**Docket A-98-49  
Item V-B2-1**

**COMPLIANCE APPLICATION REVIEW DOCUMENTS  
FOR THE CRITERIA FOR THE CERTIFICATION  
AND RECERTIFICATION OF THE  
WASTE ISOLATION PILOT PLANT'S  
COMPLIANCE WITH THE  
40 CFR PART 191 DISPOSAL REGULATIONS:  
FINAL RECERTIFICATION DECISION**

**U.S. Environmental Protection Agency  
Office of Radiation and Indoor Air  
Washington, D.C. 20460**

**March 2006**

**Figure 15-2. The WIPP Site is to the East of Nash Draw and Topographically Higher Than Nash Draw. Response to Precipitation Events at Surprise Springs Reflect Flow in Nash Draw, but not at the WIPP Site, Which is Over 8 Miles From the Land Withdrawal Boundary.**

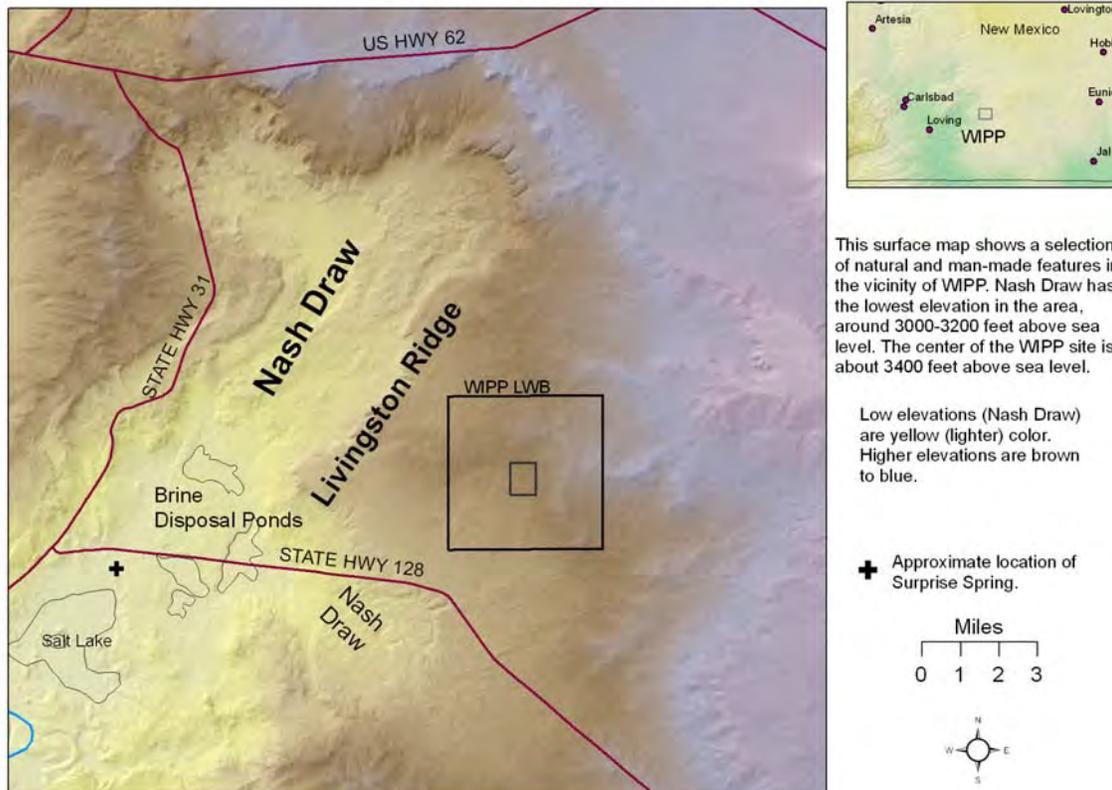
Because EPA's release requirements apply to the site, our primary interest is what happens at the WIPP site, that is, within the land withdrawal boundary (LWB), because the LWB defines the accessible environment. However, to get a better understanding of the WIPP site, it is useful to look at the area around the WIPP site. The land surface at the WIPP site generally slopes to the south and southwest. There is a topographic high, Livingston Ridge, northwest of the site, which is adjacent to Nash Draw, a topographic depression, further west (Figure 15-2).

Our understanding of the disposal system indicates that the WIPP site characteristics are distinct from Nash Draw such that extrapolations of karst in Nash Draw have little bearing on the WIPP site. Recharge characteristics and resulting discharge are one example of misrepresentation of the data by commenters. Precipitation events that occur in Nash Draw affect Nash Draw but appear to be independent of the WIPP site. The use of Surprise Spring in Nash Draw (see Figure 15-2) as an indicator of karst at WIPP is inappropriate. Surprise Spring is over 8 miles from the WIPP LWB. With the northeast to southwest flow in Nash Draw and a water table that is near the surface, Surprise Spring discharges are only a result of precipitation events that affect Nash Draw. In contrast at the WIPP site, well head data shows no response to precipitation events.

**Figure 15-3. Locations of Culebra well tests.**

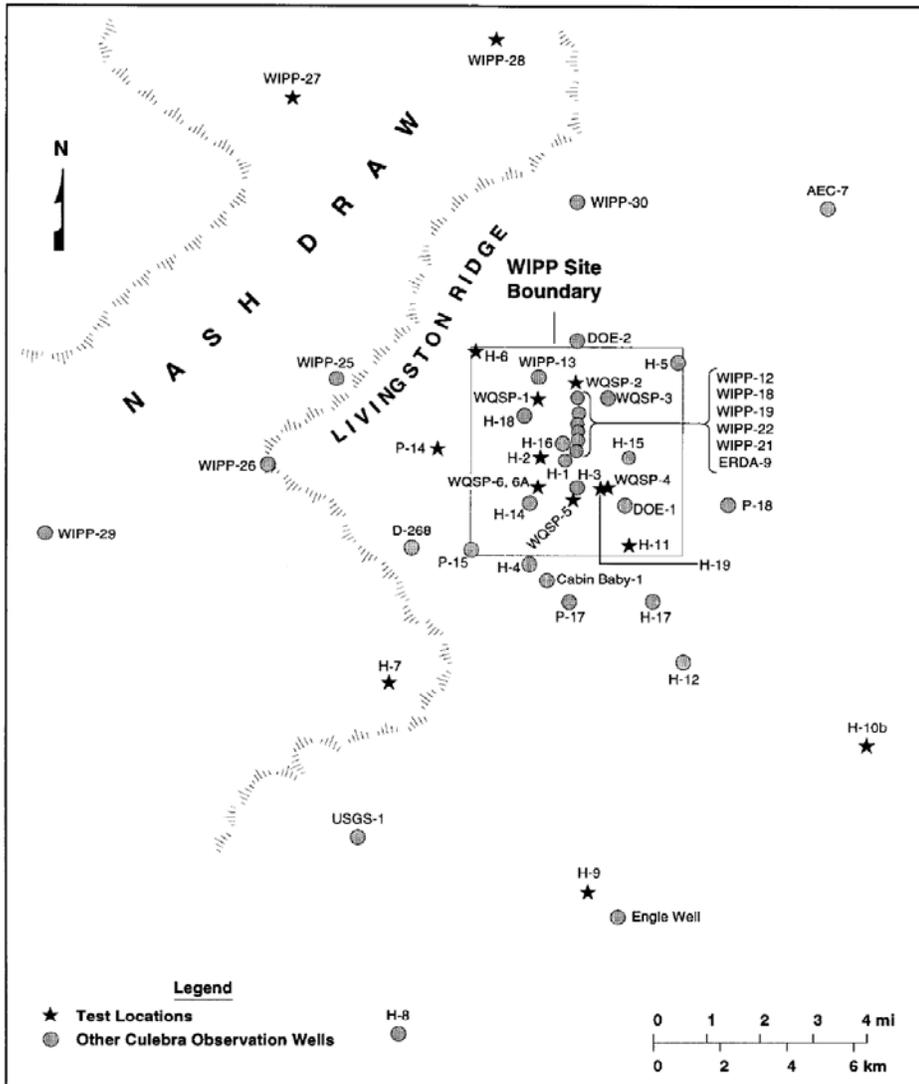
DOE has studied the WIPP site and vicinity for over thirty years (see Figure 15-3 for locations of Culebra well tests). New data is collected annually. In addition to the geologic studies, numerous pump test tests have been done, including large scale pumping tests (e.g., Beauheim and Ruskauff, 1998) and other analyses. DOE has provided these data and analysis results in the 2004 CRA and other reports. These data and their analyses provide information over large areas and form the basis for the performance assessment modeling and much of the discussion presented here. For example, in the 2004 CRA, DOE identified that the Culebra transmissivity is a function of overburden thickness—the deeper the Culebra, the lower the transmissivity (2004 CRA, Appendix PA, Attachment TFIELD). Superimposed on the depth are geologic factors such as the location relative to the margin of upper Salado dissolution and to halite in the M3/H3 interval of the Tamarisk.

The Magenta and Culebra appear to have little real-time connection to one another as claimed by some commenters. Numerous pumping tests show that the Magenta and Culebra are independent of one another (Beauheim and Ruskauff, 1998; Meigs et al, 2000; 2004 CRA Chapter 2, section 2.2.1.4.1.2). Pump tests in the Culebra elicit no response from the Magenta. Even at WIPP-25 in Nash Draw, a pumping test conducted in 2004 indicates that the Magenta and Culebra are hydraulically isolated from one another (Lorenz, 2005, p. 63). This is typical for all pump tests performed. In addition water chemistry differences also point to lack of connections between the two units.

**Figure 15-4. Four Hydrochemical Facies in the Culebra Siegel et al. 1991**

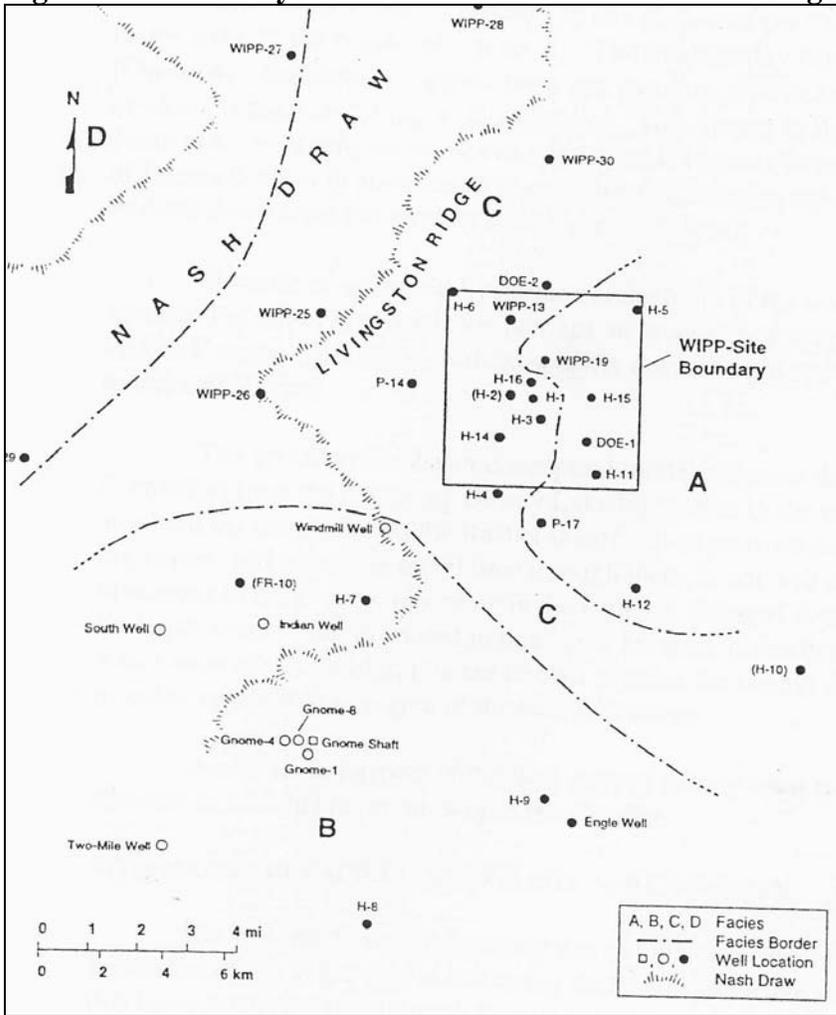
EPA believes that, on a regional scale, the groundwater basin model done by DOE reasonably predicts the current ground water flow regime and the geochemistry of the site.

**Figure 34.1. Mean and Quantile CCDFs for Total Normalized Releases: All Replicates of the CRA-2004 PABC (from Figure 6-4, 2004 Compliance Recertification Application Performance Assessment Baseline Calculation, Docket A-98-49, Item B2-51)**

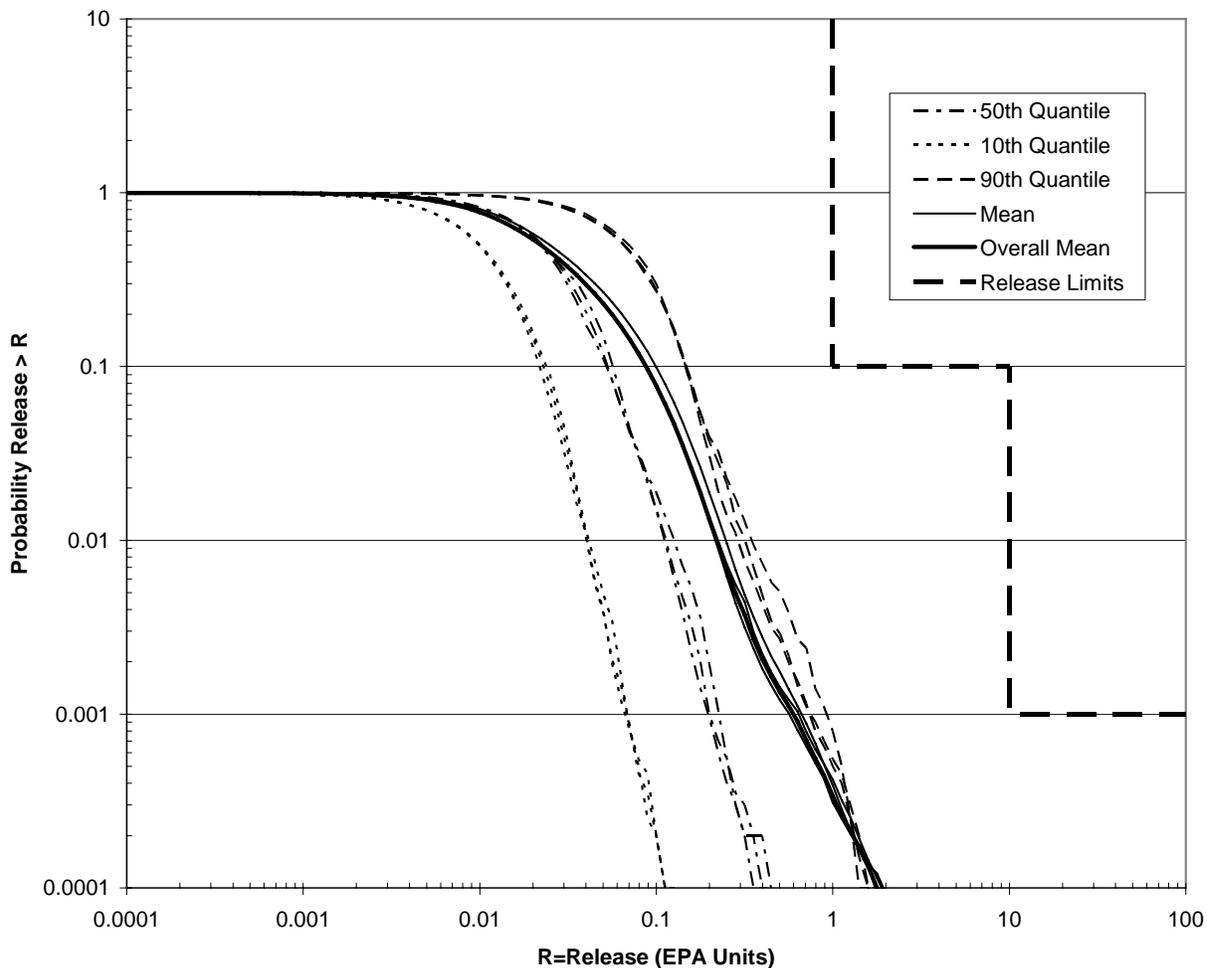
DOE used selected computer codes and input parameters to generate estimates of radionuclides for a large number of release scenarios. In total, 300 CCDFs (100 for each of the three replicates) were constructed and presented in the Performance Assessment Baseline Calculation Report (Docket A-98-49, Item II-B2-60) for total normalized releases (Figure 34-1). Three hundred realizations were needed in order to satisfy the requirements of Section 194.34(d). Normalized release results for ten thousand future simulations were used to calculate each of the 300 CCDF curves. In addition, DOE provided CCDFs for individual pathways and by replicate. EPA's analysis (Docket A-98-49, Item II-B1-16) concluded that DOE adequately presented the PA results in CCDFs, which show the probability of exceeding various levels of cumulative releases.

**RECERTIFICATION DECISION (194.34(a))**

**Figure 34-2. Total Normalized Releases for 100 CCDFs of Replicate R1 of the CRA-2004 PABC (Figure 6-1, PABC Report, Docket A-98-49, Item II-B2-60).**

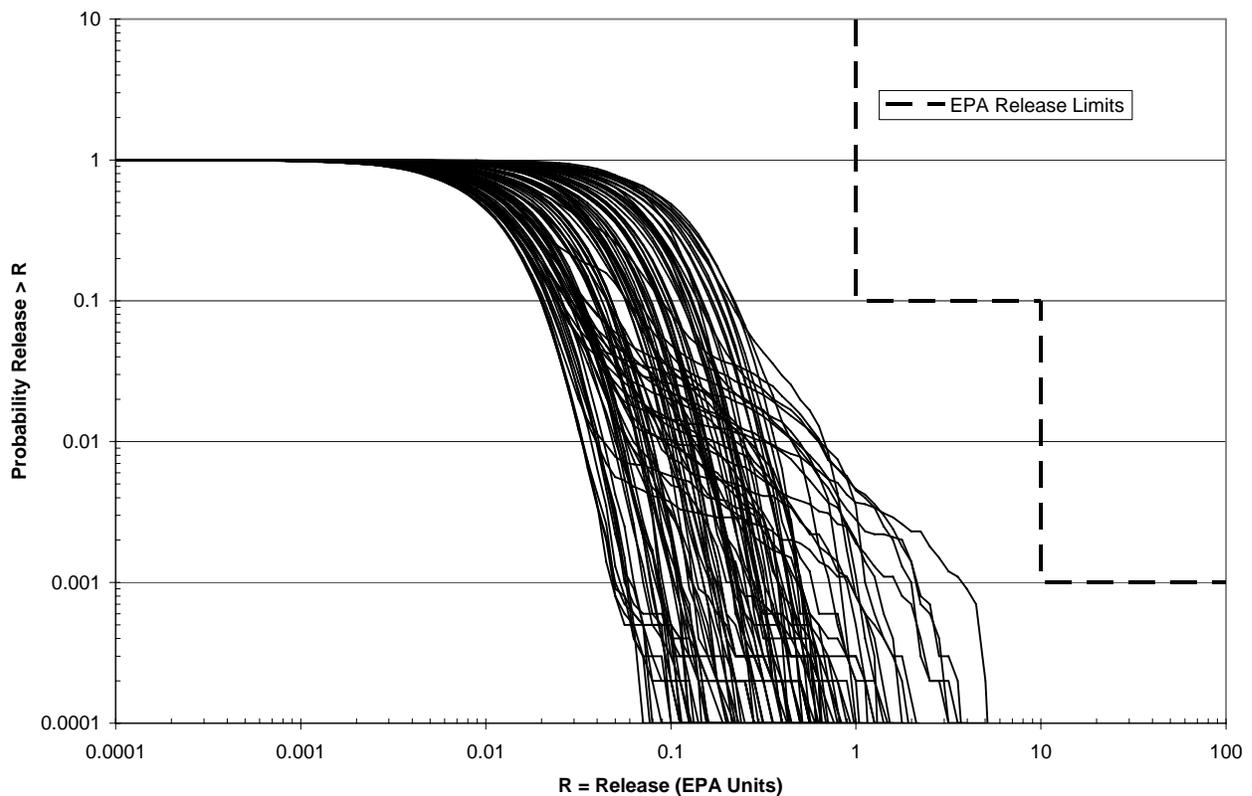
DOE presented and discussed the results of the performance assessment analysis in the 2004 CRA, Chapter 6 and the PABC report, Chapter 6 (Docket A-98-49, Item II-B2-60). Figure 34-2 shows the releases from replicate R1 of the CRA-2004 PABC.

Based on a review and evaluation of the 2004 CRA and supplemental information provided by DOE (FDMS Docket ID No. EPA-HQ-OAR-2004-0025, Air Docket A-98-49) and the fact that DOE included the full range of CCDFs as required by this section, EPA determines that DOE continues to comply with the requirements for Section 194.34(e).
